PLANNING COMMISSION MEETING

Wednesday, June 21, 2023 at 7:00 PM
Hamburg Township Hall Board Room

To: Planning Commissioners
From: Amy Steffens, AICP
Planning and Zoning Director
Date: June 21, 2023

Project address and Description: **Site Plan Review (SPA 23-0001)** for the construction of a 22,360 square-foot multi-tenant commercial building, with associated parking and site improvements. Site location 7749 E M-36; TID 15-25-200-068.

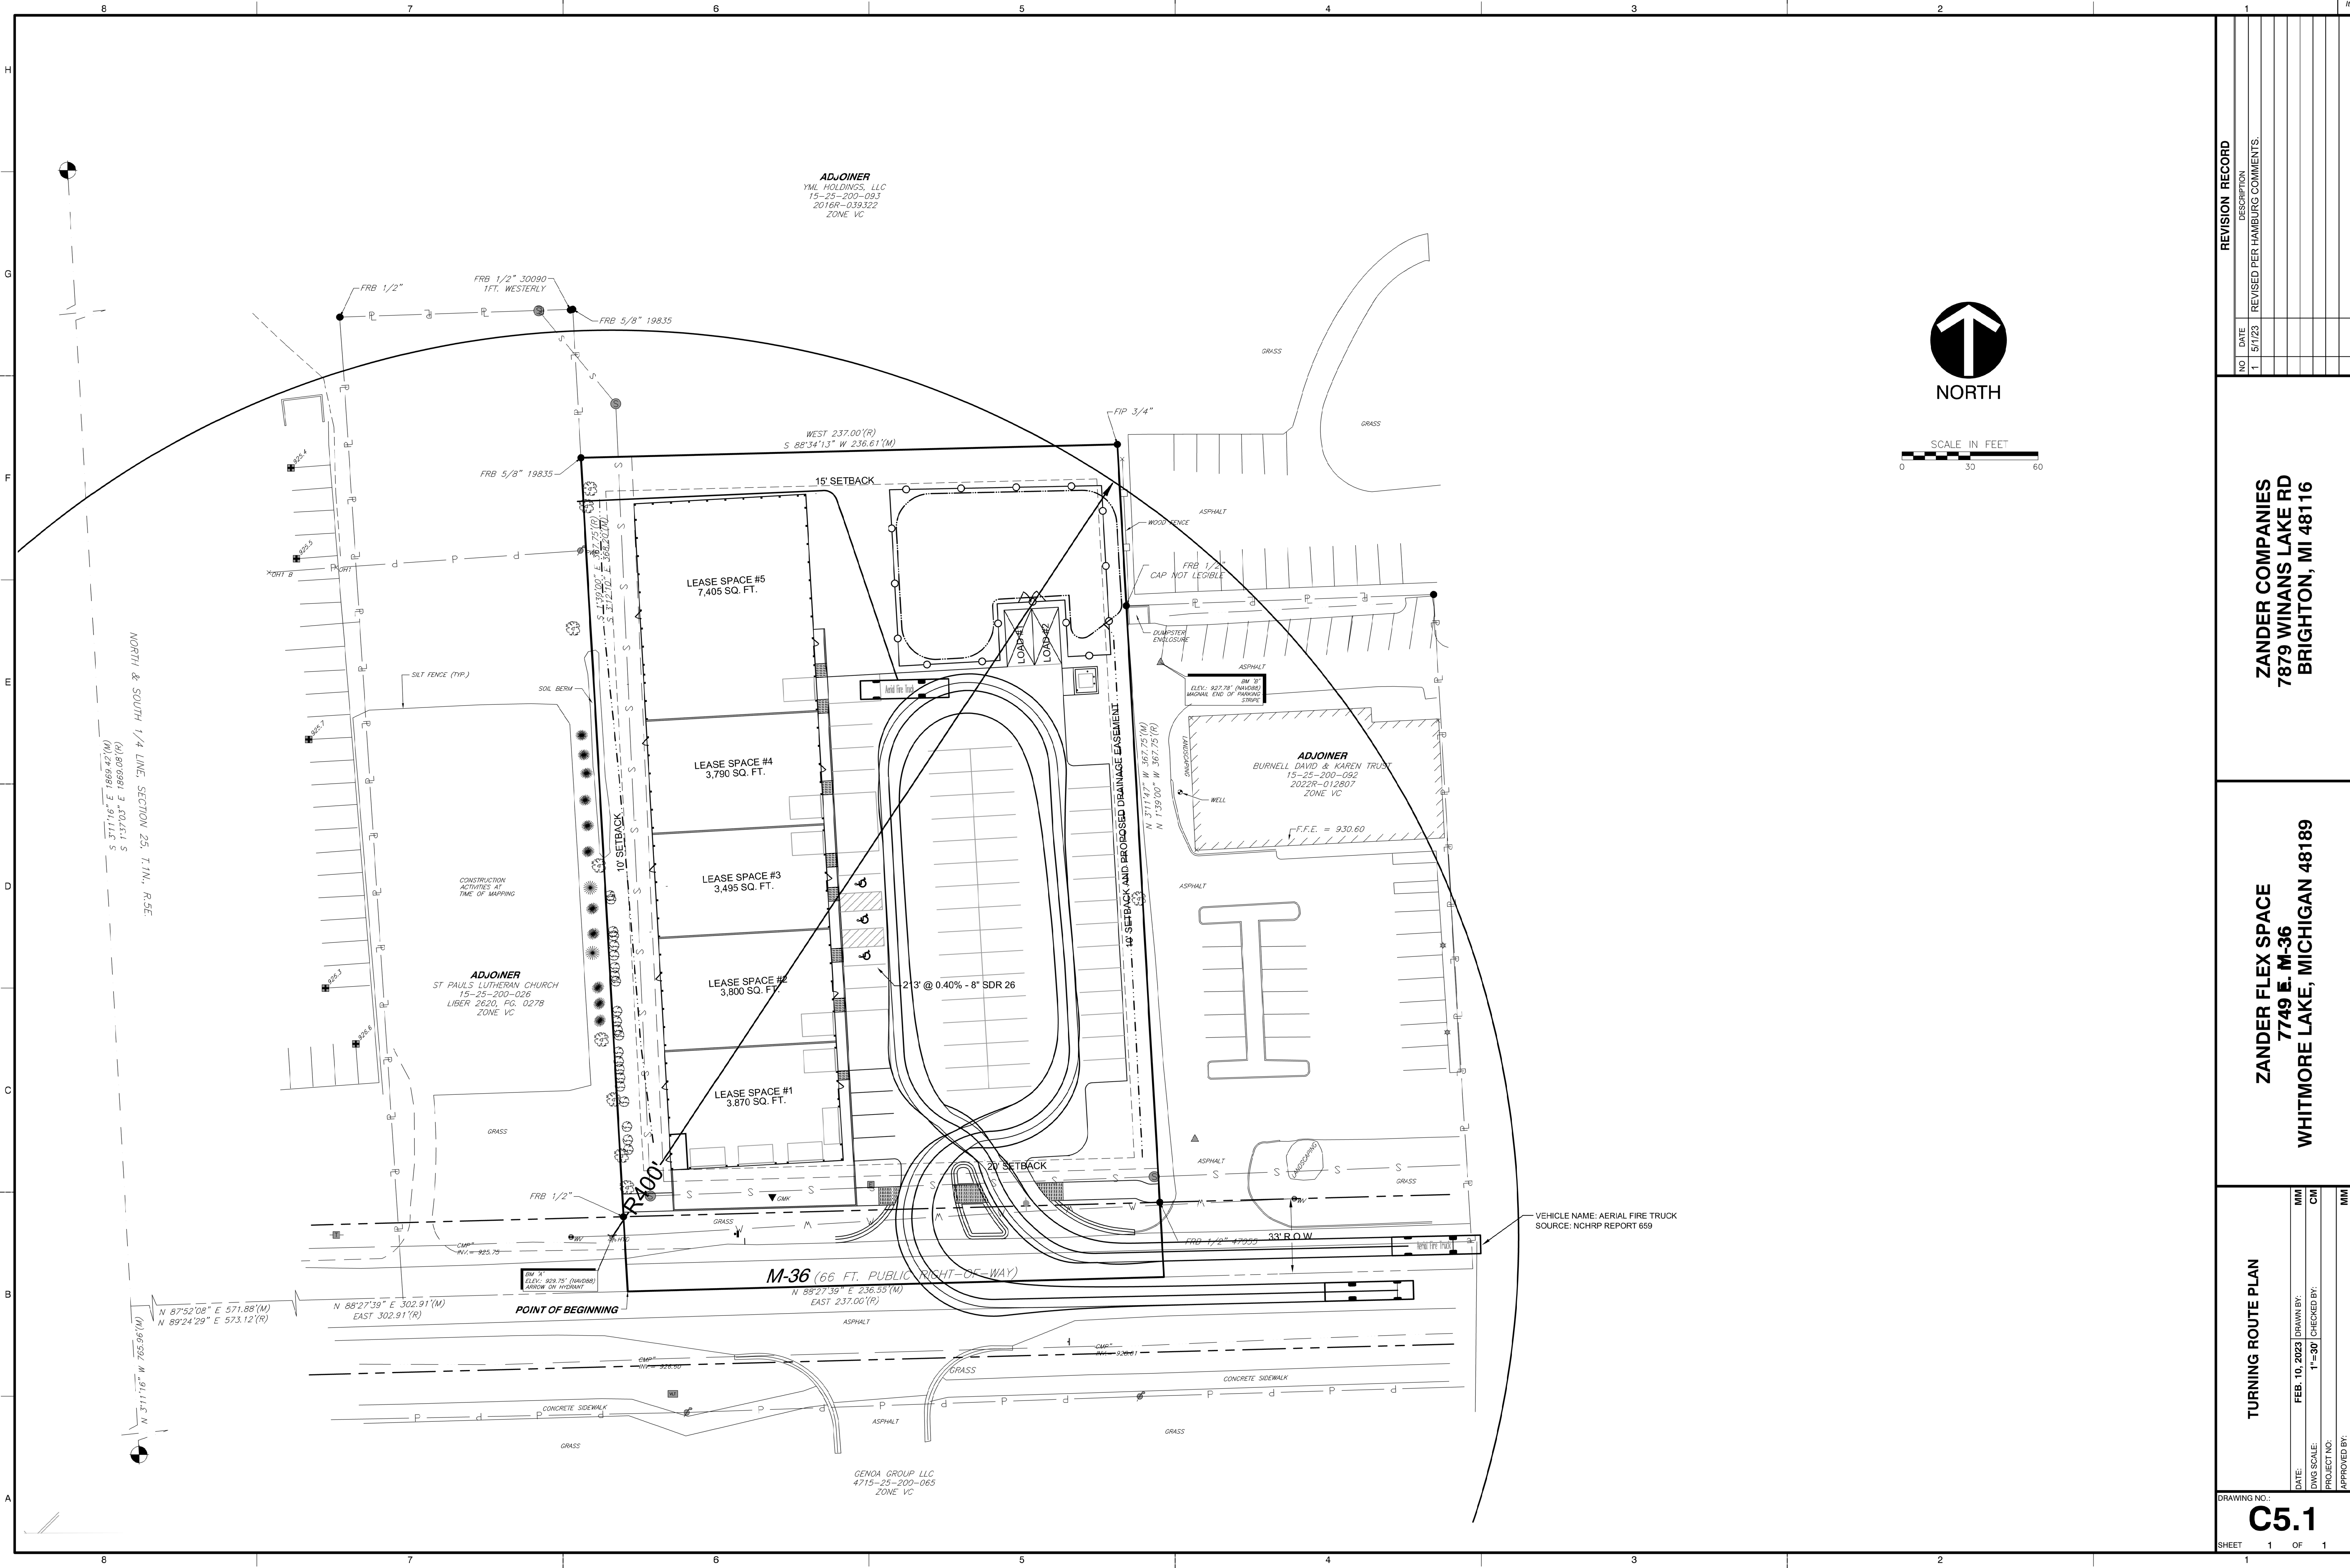
4. If Fire Alarm or suppression is deemed to be required, plans shall be submitted directly to the Hamburg Township Fire Department for review.
Fire suppression is not required. See fire rated walls detail on T1.1.

8. Architectural Building plans shall be submitted for review by the Fire Department.

Concur. The architectural plans are attached.

**EAST ELEVATION**

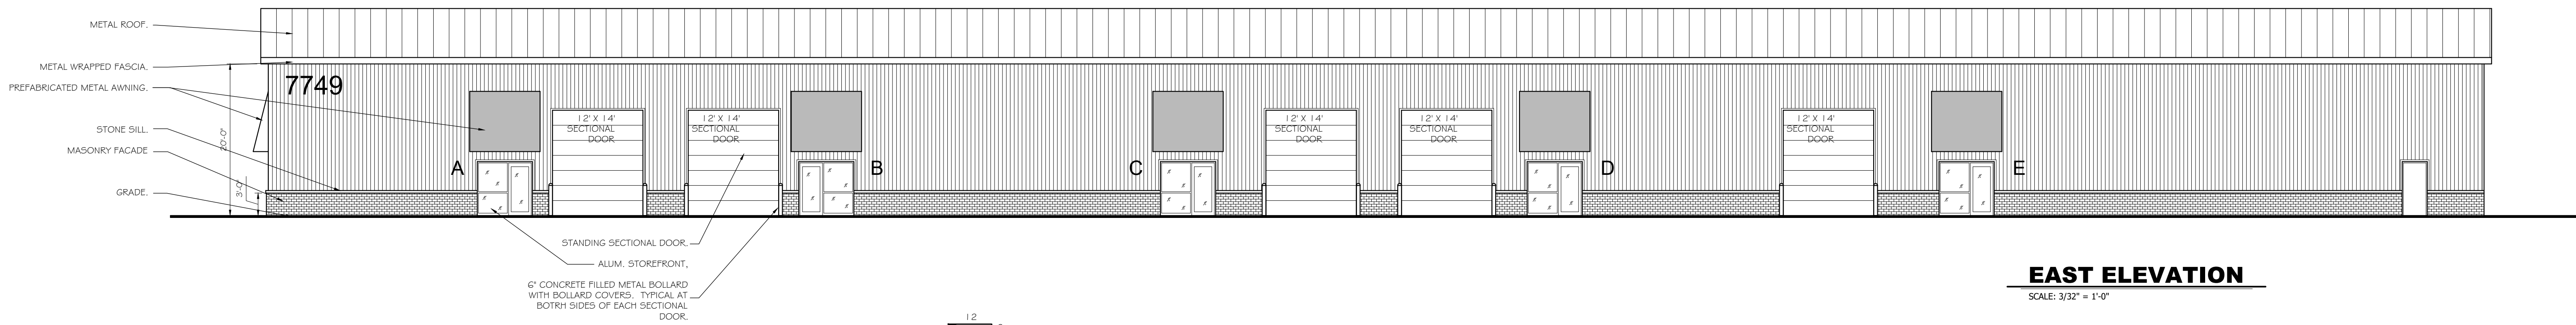
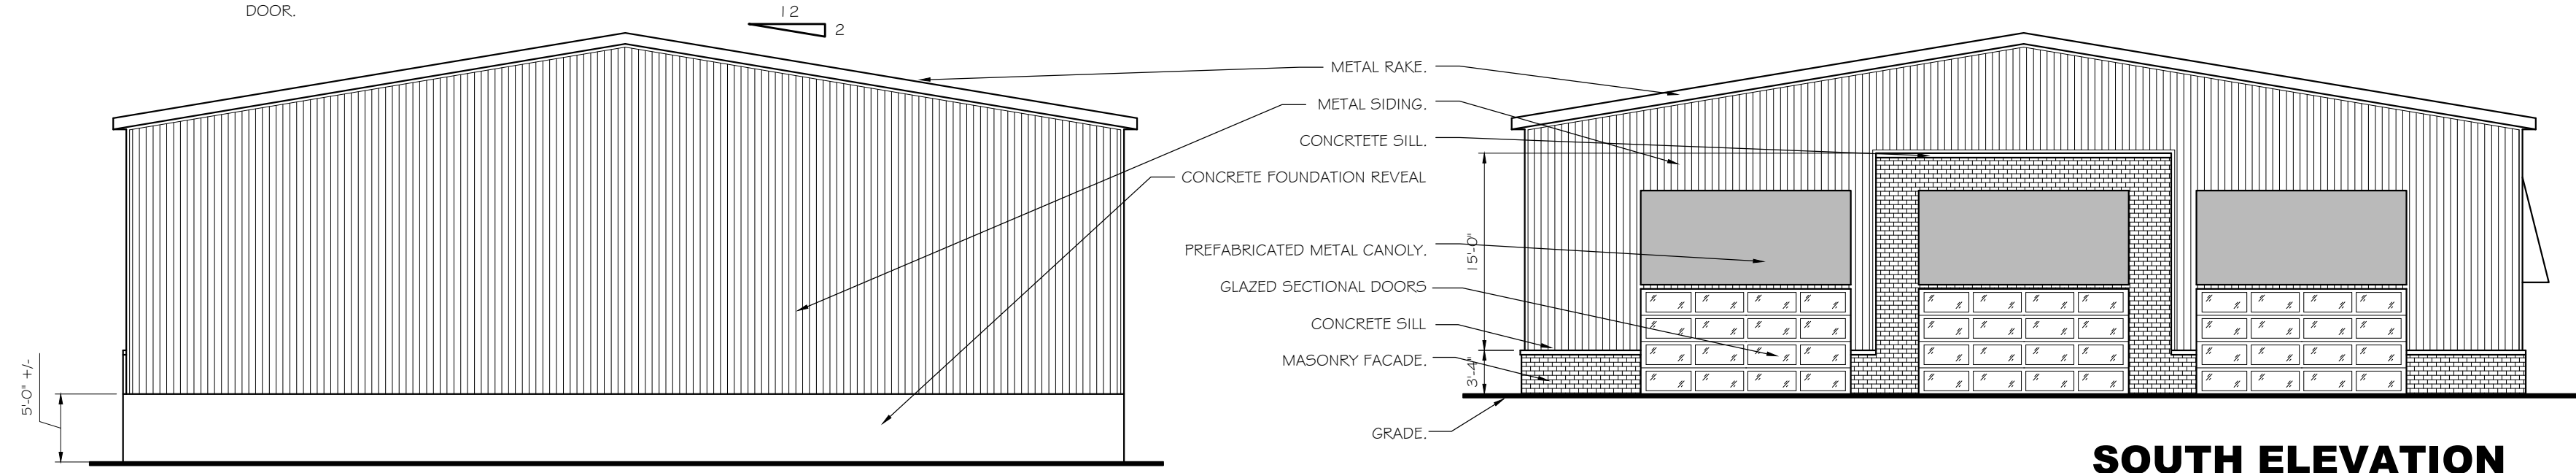
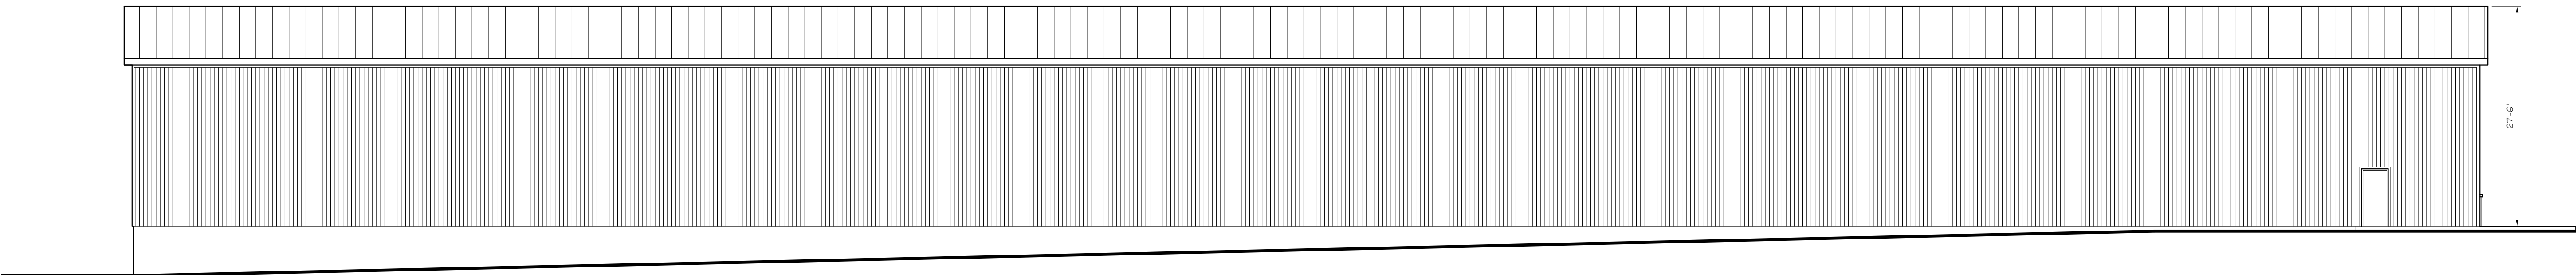
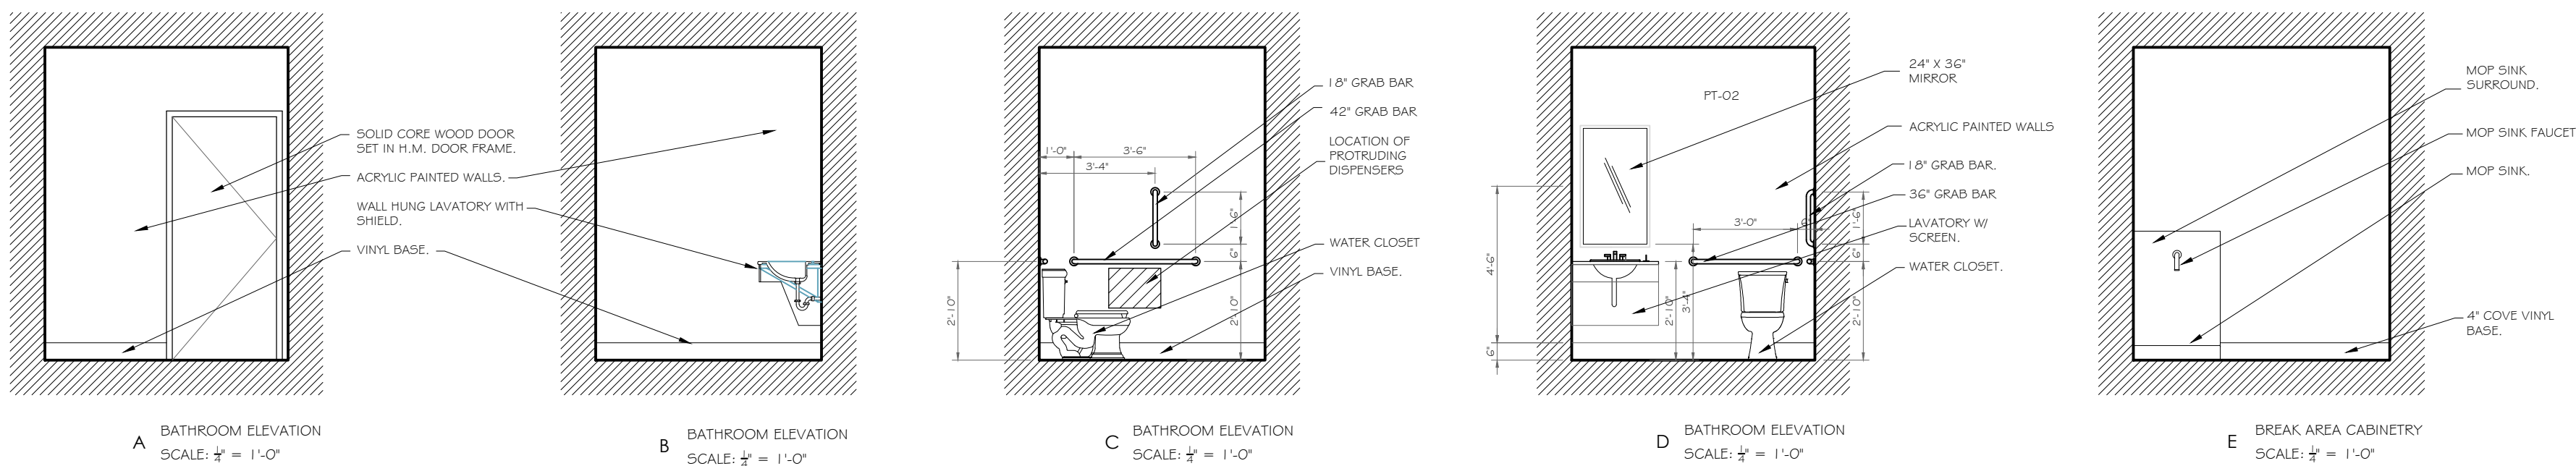
Much discussion was had on staff's and Commissioner's concerns on the proposed architecture of the commercial structure. The Commission indicated that as proposed the building is not acceptable due to this site being in the gateway to the township and in the Village Center zoning district. Staff's report from May 31, 2023 provides in-depth analysis of the architecture as compared to the Village Center requirements of Section 36-73(7). The Commission made architectural approval a condition of final site plan approval.

13. No outside storage areas are permitted.
14. Prior to final site plan approval architecture shall be approved by the Planning Commission.
15. Shrubs shall be maintained at three feet tall and additional screening shall be provided along the east property boundary.

On June 13, 2023, the applicant’s architect, Todd Calloway, Commissioner Victor Leabu, and I (Amy Steffens), met to discuss building architecture. It was agreed that the Mr. Calloway would show elevations with a covered porch across the front south elevation, provide awnings above the entry and overhead doors on the east elevation, and provide additional masonry detail. As of this writing, no building elevations have been submitted but staff is confident that the applicant will work with the township to create a building that meets the intent of the Village Center zoning district.
